# Assessment Officer Report

PA2504154 – 1-23 Lilliput  
Street, Broadmeadows

Officer Assessment Report  
Development Assessment

Figure 2 - Extract of the proposed signage across the site

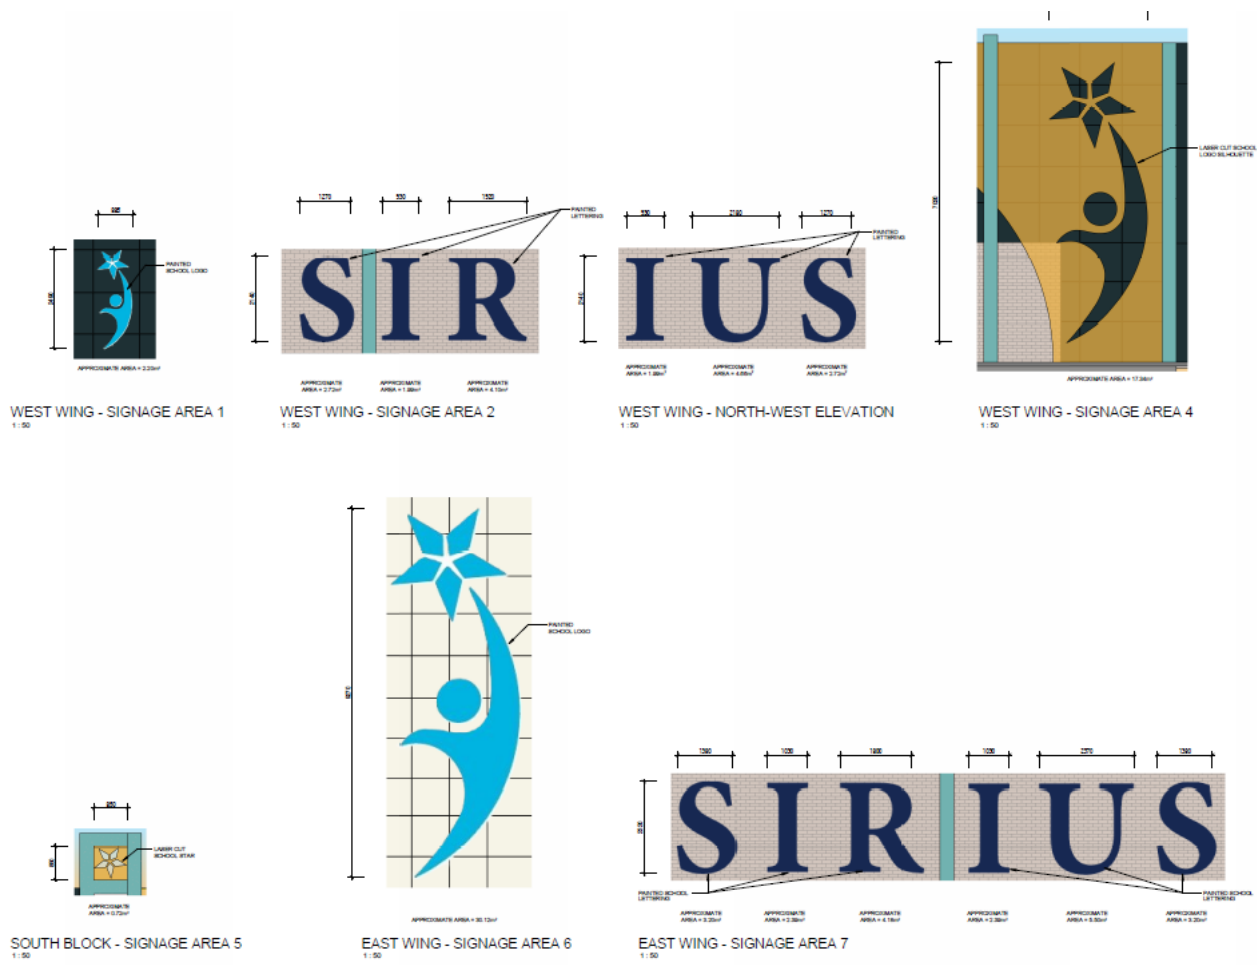
91. As generally seen on the façade extracts, the proposal incorporates multiple business identification signs across the facades of the buildings. None of these signs are internally illuminated.
92. Overall, the extent of signage is acceptable and each of these signs have been assessed within the table below

Figure 4 - Extract of the ground floor plan of the proposed West Wing building

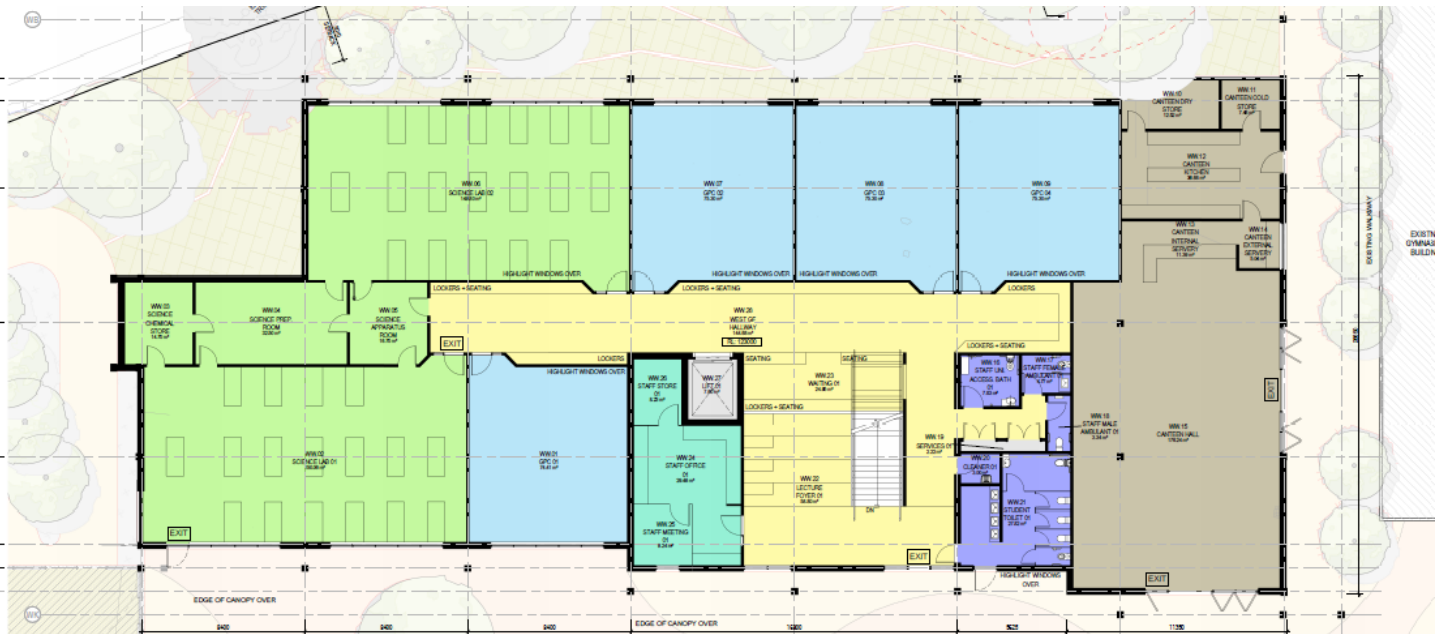
78. The first building – West Wing – faces onto Nathalia Street, is setback between 3 metres to 15 metres. Within that setback area, new canopy trees will be planted within that area, and integrated with existing trees that are being retained within that setback. West Wing building has a maximum height of approximately 8.3 metres (to the top of the parapet) with two floors of classrooms, bathrooms and flexible learning spaces. This is appropriate as to will sufficient enable flexible learning opportunities for students.

Figure 5 - Extract of the north-west elevation of Wing West (when viewed from Nathalia Avenue)

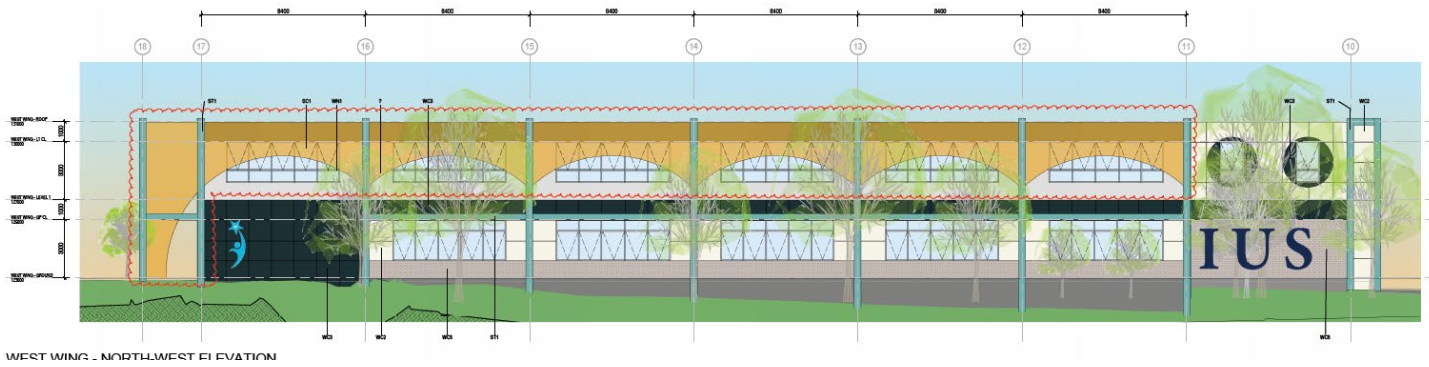
80. West Wing and South Block utilise a distinct architectural language with circles and arching features, and is clad with a combination of brick and metal cladding of with distinctive colour palette to suit the school branding. This creates a built form that is visually interest and distinctive to that of a residential or commercial building and ensure contemporary architectural outcome.

Figure 8 – Extract of the south elevation of South Block (when viewed from Cobram Avenue)

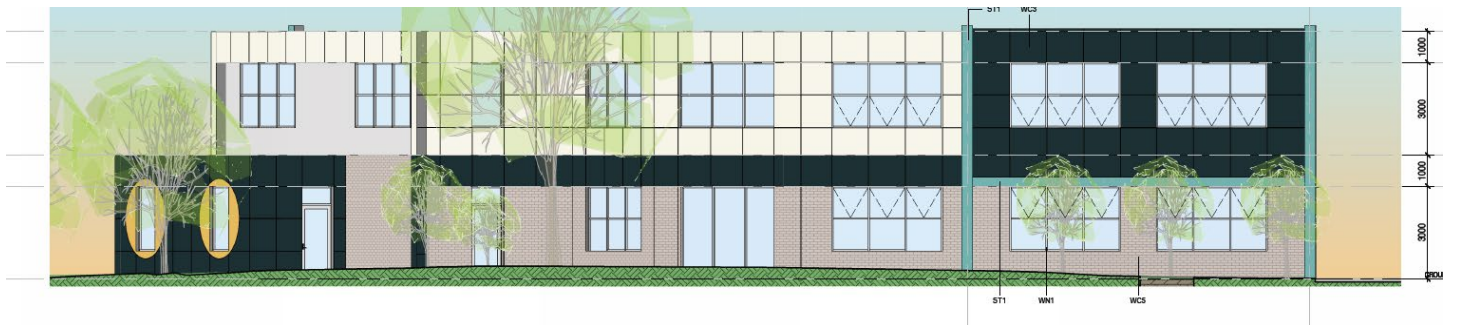
79. The second building – South Block – faces onto Cobram Street is setback generally between 3 metres to 8 metres from that street. This setback has been sufficiently setback so as to avoid unreasonable encroachment into the existing canopy trees that are being retained as part of the proposal.

Figure 12 - Extract of the north-west elevation of East Wing

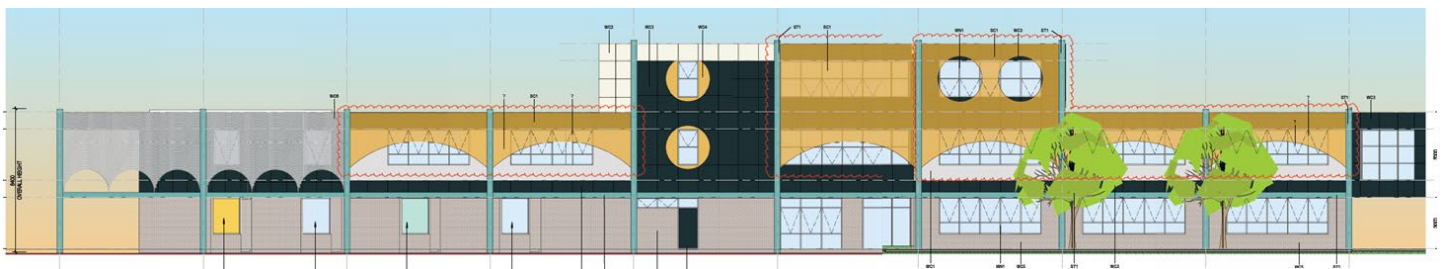
86. Elevations show that the 3-storey component is generally positioned within well away from the residential hinterland ensuring that there will be no unreasonable visual impacts. As such, the height is considered to be acceptable.

87. East Wing utilises a distinctive architectural language similar to West Wing and South Block. In particular East Wing also utilises with circles and arching features, and is also clad with a combination of brick and metal cladding of with distinctive colour palette to suit the school branding.
